30-045-24869 GALLEGOS CANYON UNIT COM H #180E  
BP AMERICA PRODUCTION COMPANY

## Revisions to Operator-Submitted EC Data for Sundry Notice #492133

Re: Permanent Abandonment  
Well: GCU Com H 180E API: 30-045-24869

# BLM FLUID MINERALS Geologic Report

## Wellbore Diagram

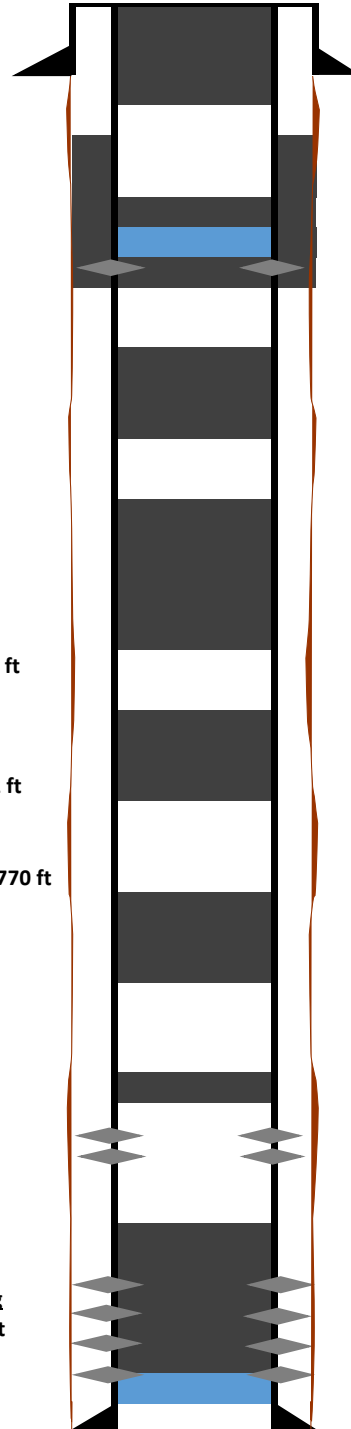
- Notify NMOCD 24 Hours prior to commencing activities
- In addition to the BLM-approved plugs, include:
  1. Ensure coverage 4962' – 4862.' OCD Gallup pick @ 4910.'
  2. Extend the Mancos plug 4055' – 3955.' OCD Mancos pick @ 4005.'
  3. Include Chacra plug 2270' – 2170.' OCD Chacra pick @ 2220.'

1. Plugging operations authorized are subject to the "General Requirements for Permanent Abandonment of Wells on Federal and Indian Lease."
2. Farmington Office is to be notified at least 24 hours before the plugging operations commence (505) 564-7750.
3. Plug #1 requires a cement retainer to be set at 5732'. (This retainer appears on the WBD but not in the procedure.) Pump 20 sacks of cement below the retainer and 10 sx on top of the retainer.
4. Plug #2 requires 40 sacks of cement below the cement retainer set at 4864' and 10 sacks of cement on top of the retainer.
5. Plug #3 is required to be moved to 4055'-3905'. Adjust cement volume as necessary.
6. Plug #6 is required to be enlarged to cover 1298'-855'. Adjust cement volume as necessary.

- BLM geologist's picks for the top of the Fruitland, Lewis, Chacra, Cliff House, Mancos, and Graneros Formations vary from operator's picks.
- Adjust plugs as detailed in the COAs attached to the Sundry NOI.
- Log analysis of reference well #2 (attached worksheet) indicates the Ojo Alamo sands investigated are likely to contain fresh water ( $\leq 5,000$  ppm TDS). These fresh water sands are protected behind the surface casing and are adequately covered by the proposed surface plug.
